CITY of NOVI CITY COUNCIL

Agenda Item F
June 2, 2014

SUBJECT: Approval of a request from Robertson Charneth Fen, LLC for a variance from Section 11-278(b)(5)) of the Design and Construction Standards, which requires sidewalks to be placed a minimum distance of five feet from the back of curb, to allow the applicant to construct the sidewalks at the back of curb for the Charneth Fen project (parcel number 22-10-426-001).

Re: Charneth Fen Sidewalk Variance Request

sheet no.
L-2

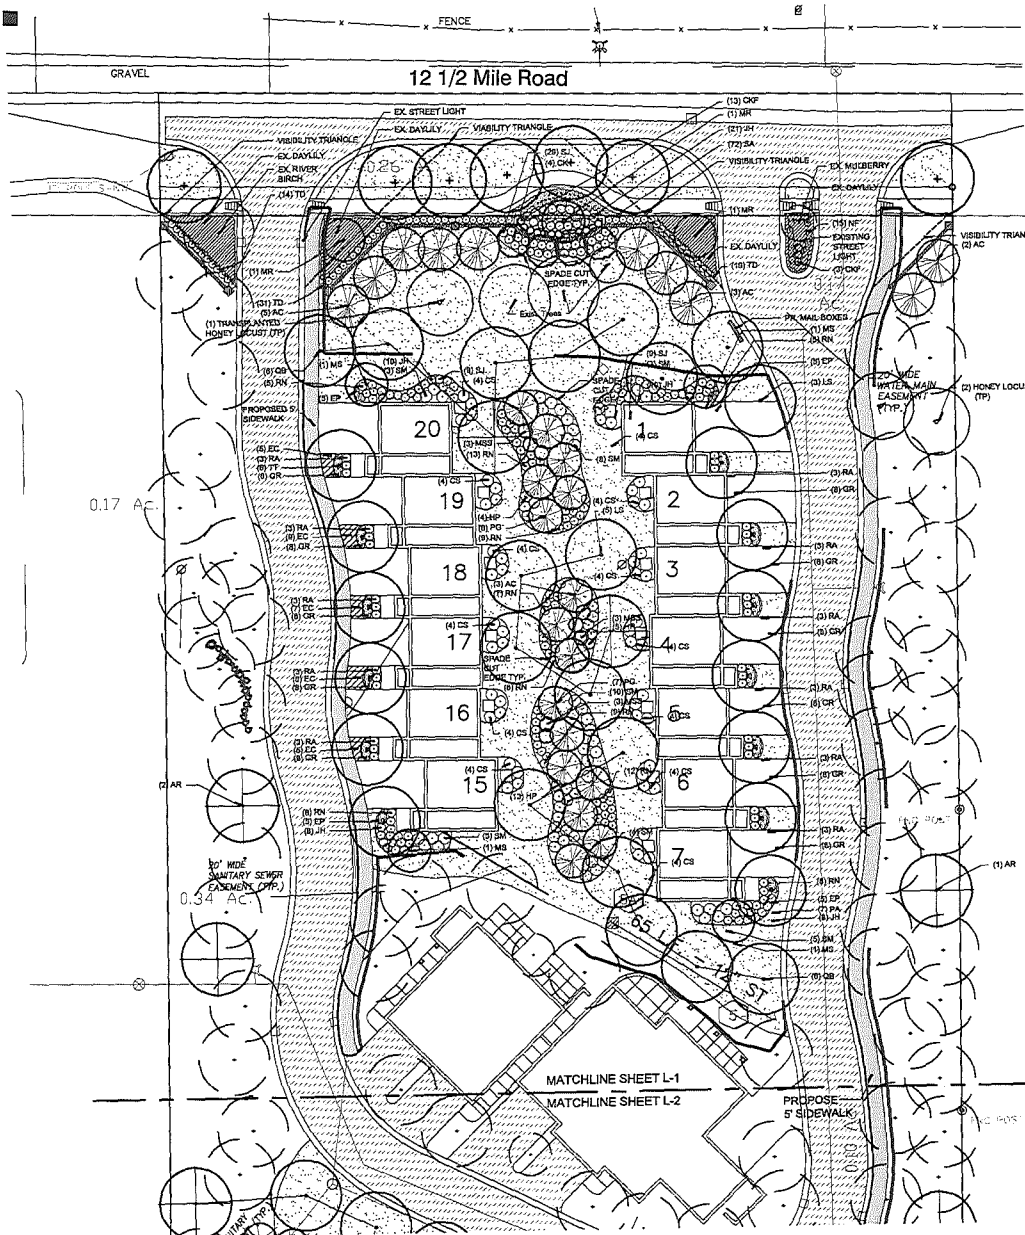
At this time, Robertson is in the process of preparing our final Stamping Plans, and would like to request a variance to the requirement that sidewalks be placed a minimum of 5' from the back of the curb, as specified in Section 11-278(b)(5). Robertson's request is predicated upon the following facts:

1. A literal application of the requirement would result in a practical difficulty due to the existence of all the installed improvements and the Robertson's desire to create a gracious landscaped courtyard between the two new buildings. The existing road pattern follows a serpentine pattern, and if the sidewalks are placed 5' behind the curbs and a twenty foot distance is maintained for guests to park on the drives, not only would the courtyard be compromised but some of the drives would become excessively long.

2. Placement of the sidewalks at the back of the curb on Traci Trail and Melanie Lane will not substantially change the functionality or usability of the walks from the ordinance requirement. The walks location still provides residents with direct pedestrian access to the walkway system on 12 ½ Mile Road which was the goal of the Council when this issue was discussed.

3. In granting this variance, as shown on the plans, the Applicant has preserved the maximum amount of existing landscaping located in the area between the curb and the property line. This area is steeply sloped from the back of curb to the property line and moving the sidewalk five feet will result in unnecessary additional grading and retaining.

The applicant has provided reasons for the proposed variance including maintaining the integrity of the proposed adjacent courtyard, preservation of landscaping, elimination of the need for grading, and sustaining the functionality of the sidewalks. In the event that City Council finds that the standards for a variance or waiver have been met, our office sees no legal impediment to granting the variance, subject to the condition that the Engineering Division has also reviewed and approved the proposed plan.
